DRAINAGE AND TRANSPORTATION INFORMATION SHEET

Project Title: 6305 Alderete Ct NW G&D PLAN Building Permit #: _____ City Drainage #: _____
 DRB#: _____ EPC#: _____ Work Order#: _____
 Legal Description: Lot 17, Block 8, Unit 22 Volcano Cliffs Subdivision
 City Address: 6305 Alderete Ct NW, ABO, NM 87120
 Engineering Firm: Metro Development, Inc. Contact: Steve Metro
 Address: 8860 Desert Finch Ln NE, ABO, NM 87122
 Phone#: 505-280-4553 Fax#: 505-348-4055 E-mail: steve.metro@wilsonco.com
 Owner: Joe Anderson Contact: Joe Anderson
 Address: Custom Home ABO, NM
 Phone#: 505-235-3224 Fax#: _____ E-mail: jraffa@comcast.net
 Architect: _____ Contact: _____
 Address: _____
 Phone#: _____ Fax#: _____ E-mail: _____
 Surveyor: Metro Development, Inc. Contact: Steve Metro
 Address: 8860 Desert Finch Ln NE, ABO, NM 87122
 Phone#: _____ Fax#: _____ E-mail: steve.metro@wilsonco.com
 Contractor: Guyman Construction Solutions LLC Contact: Rudy Guyman
 Address: 6020 Industry Way ABO NM 87105

GRADING AND DRAINAGE PLAN
LOT 17, BLOCK 8, UNIT 22, VCS
ADDRESS: 6305 Alderete Ct NW

**RE: Lot 17 Block 8 Unit 22 Volcano Cliffs
6305 Alderete Rd NW
Grading and Drainage Plan
Engineers Stamp Date 5/28/15 (D10

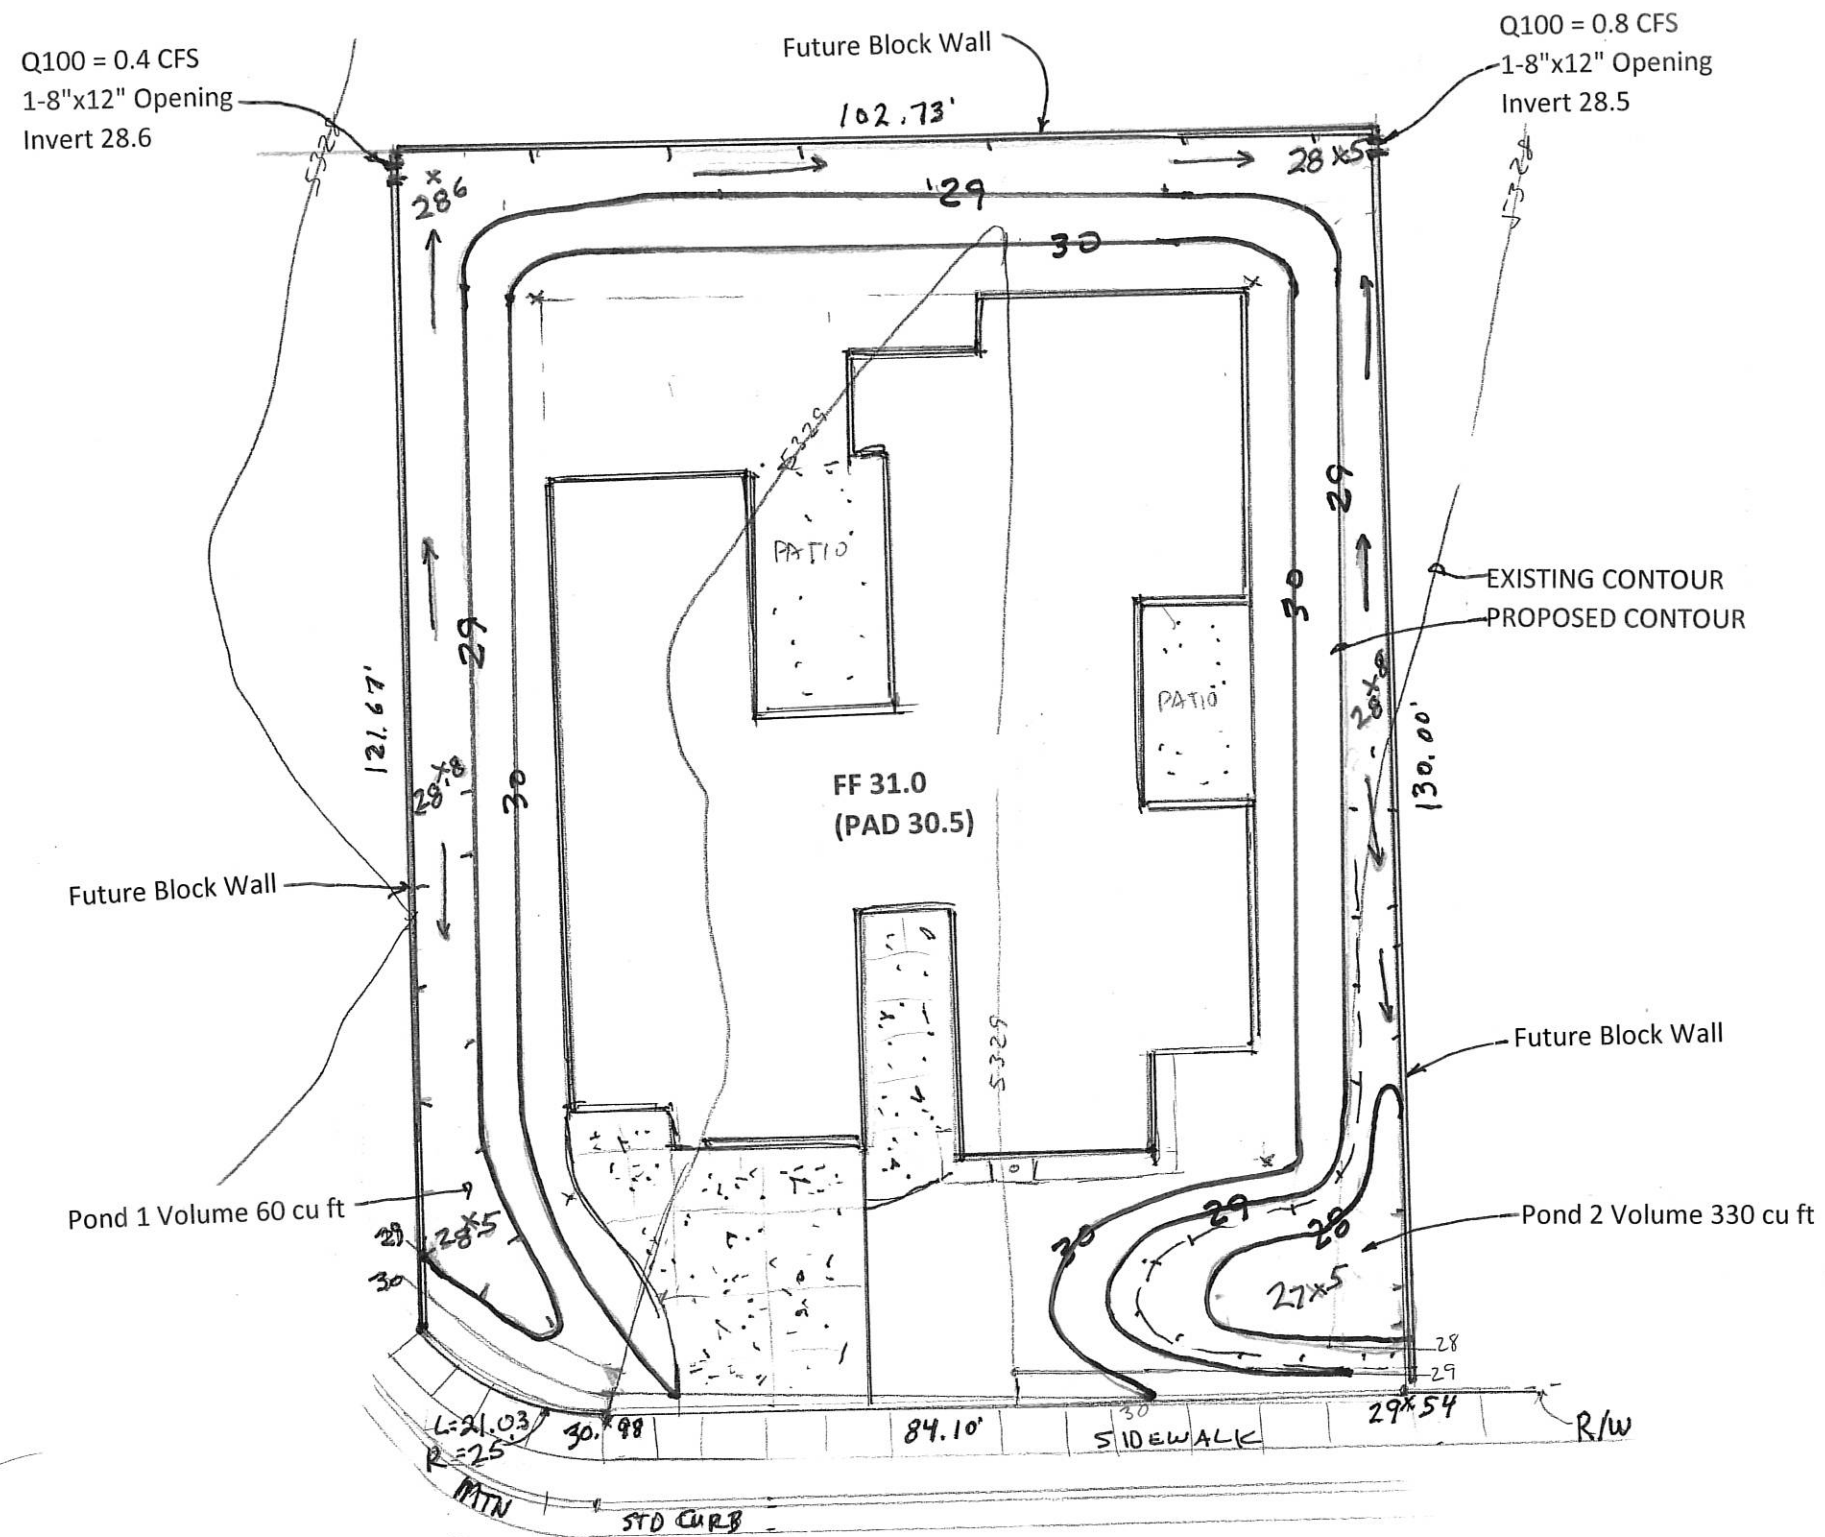
Based upon the information provided in your submittal received 5/28/2015, this plan is approved for Grading Permit and Building Permit.

Please attach a copy of this approved plan to the construction sets in the permitting process prior to sign-off by Hydrology.

Prior to Certificate of Occupancy release, Engineer Certification per the DPM checklist will be required.
